RE: 16497 South Kennedy Drive

I reviewed the drawings and evaluated the neighborhood context. My comments and recommendations on the design are as follows:

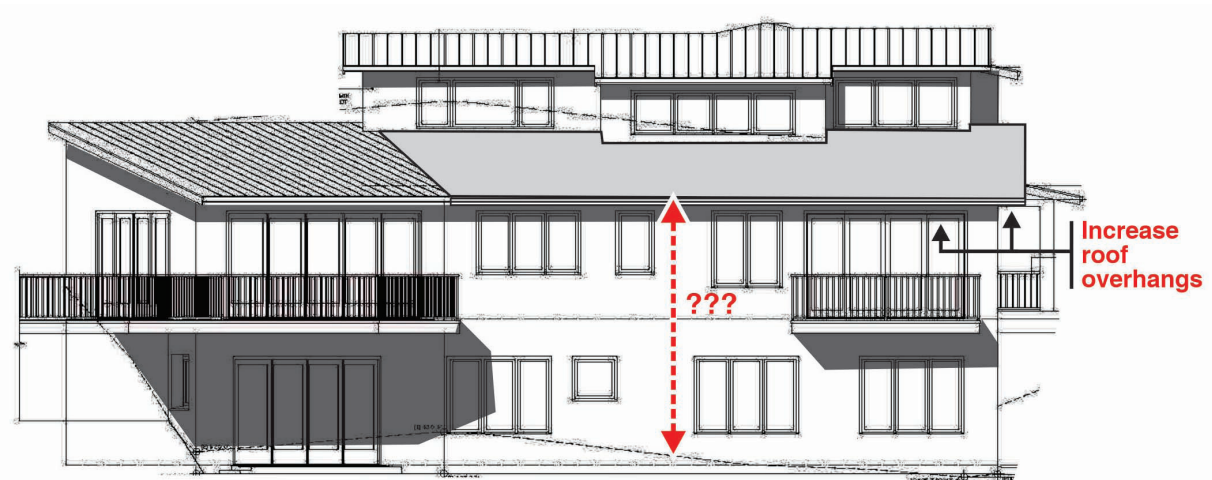
In my review I saw only two issues that staff may wish to explore further.

1. The roof overhangs at the second level are smaller than the upper level.
2. There is a portion of the southwest downhill facade that has a two story flat face which would appear to be inconsistent with both the Town's Hillside Development Standards and Design Guidelines and the Town's Single Family Residential Design Guidelines.

Two story wall segment would appear to not be consistent with both the Hillside Design Standards and Guidelines and the Town's Residential Design Guidelines

1. Increase the roof overhang to provide a stronger eave shadow line to mitigate the two story facade.
2. There may be two ways to address the issue of the two story flat downhill facade section:
 - A. Leave it as proposed given the amount of downhill landscaping that is currently a buffer to views from the home below and the applicant's commitment to plant screen landscaping at the lower property line.

- B. Extend the balcony across the facade connecting the currently proposed balcony and deck.
